Re: 03PD040
Scott Craig PUD App.

HEARING FOR PLANNED DEVELOPMENT APPLICATION

Premises Affected: Lot 6, Block 1 Skyview North Subdivision, Section 10, T1N,
R7E, BHM, Rapid City, Pennington County, South Dakota

File Number: 03PD040

Preliminary Plot Plan
for Lot 5
John and Carol Davies

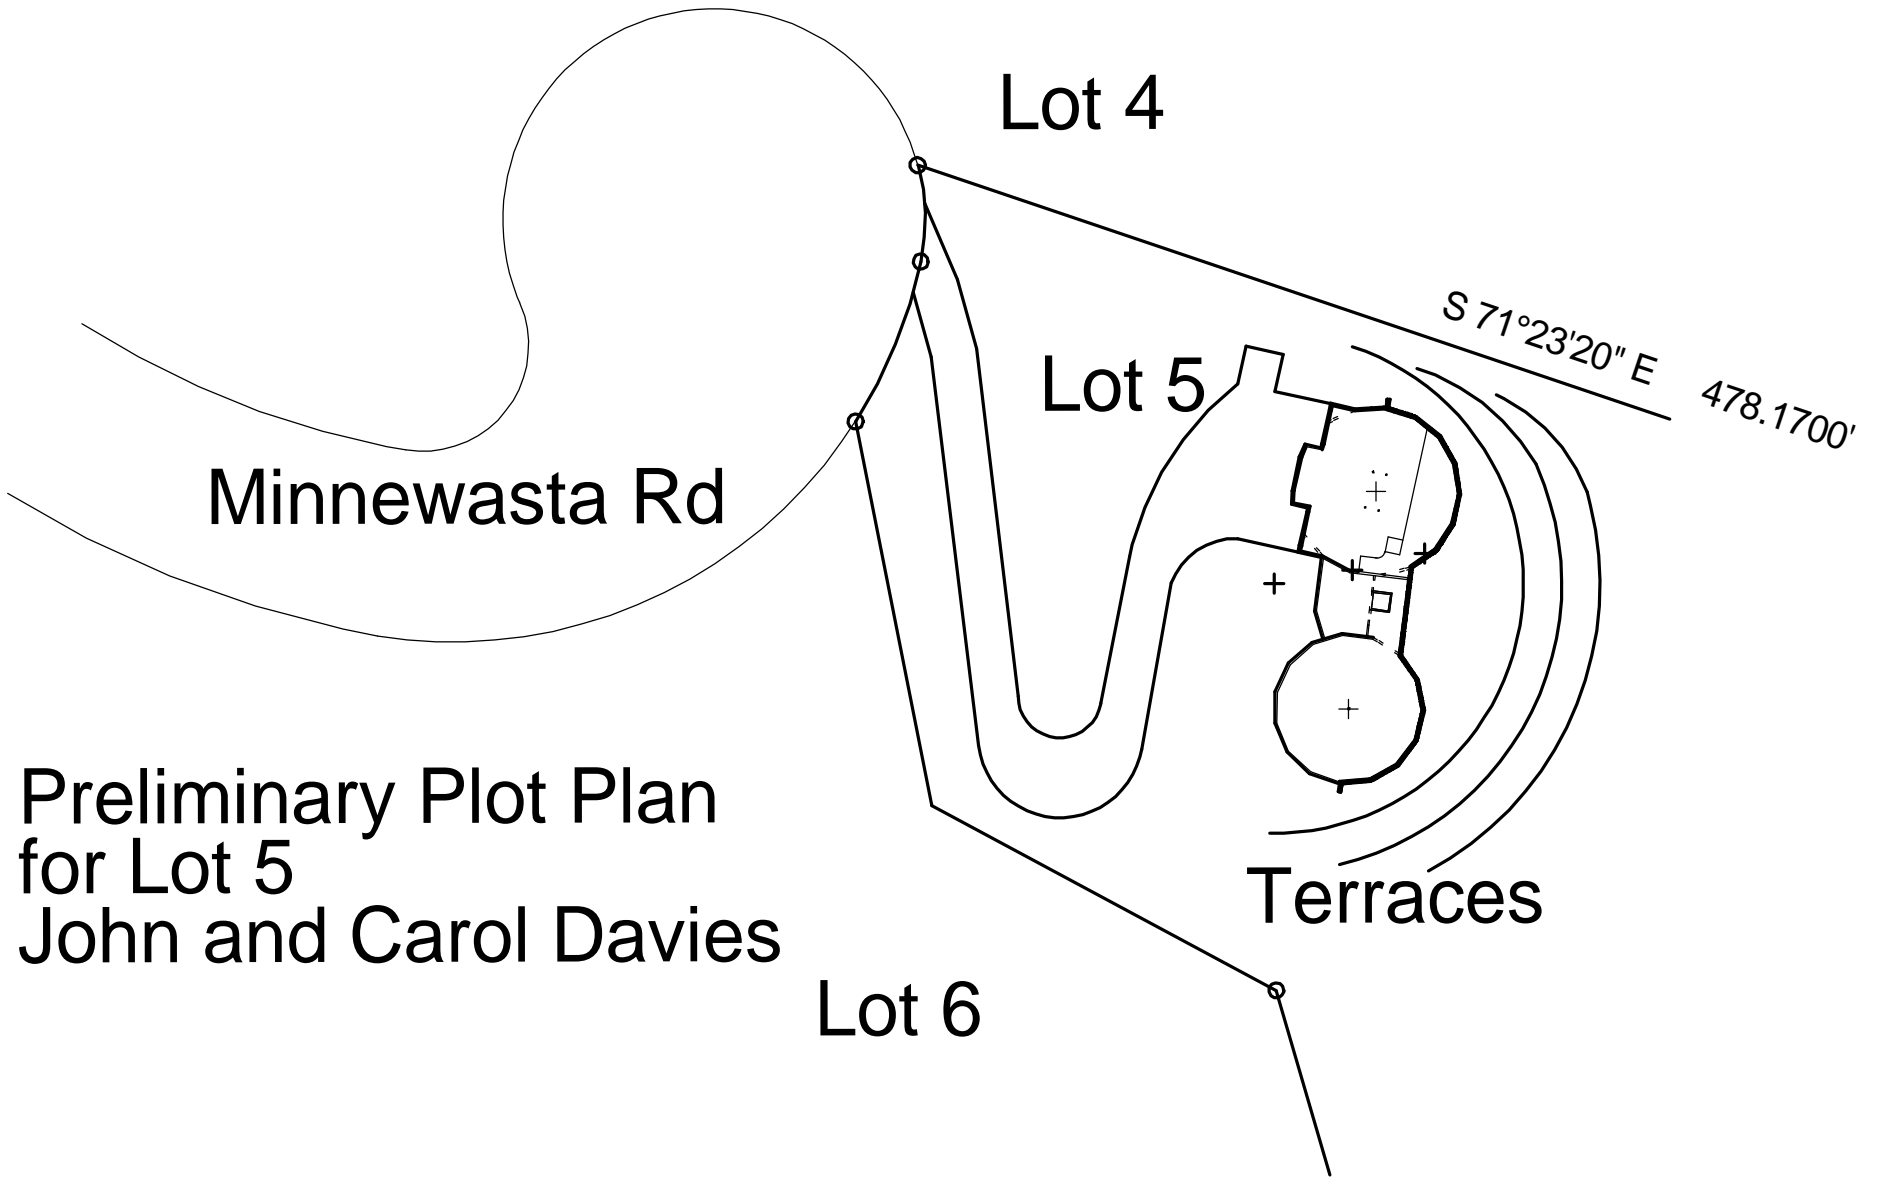
We understand Mr. Craig has requested an amendment to reduce the building envelope on a side yard set back. The reduced side yard set back will be adjacent to our lot, Lot 5. We are not opposed to the reduced set back provided that the reduced setback does not interfere or encumber our ability to develop our lot and provided that Mr. Craig provides for the natural drainage across Lot 6.

We have enclosed a copy of our preliminary plot plan for the residence that we intend to build in about one year. We plan to build a driveway that will be adjacent to Lot 6 and will be near the lot line where Mr. Craig intends to have the reduced set back. We will need to locate our driveway as shown to be able to meet grade requirements. We do not have grade plans completely engineered at this time.

Mr. Craig should consider the proximity of our intended driveway to the residence he is building and plan for barriers for light and sound that may affect occupants. We are also concerned that water that naturally flows across Lot 6 could be diverted to flow across Lot 5.
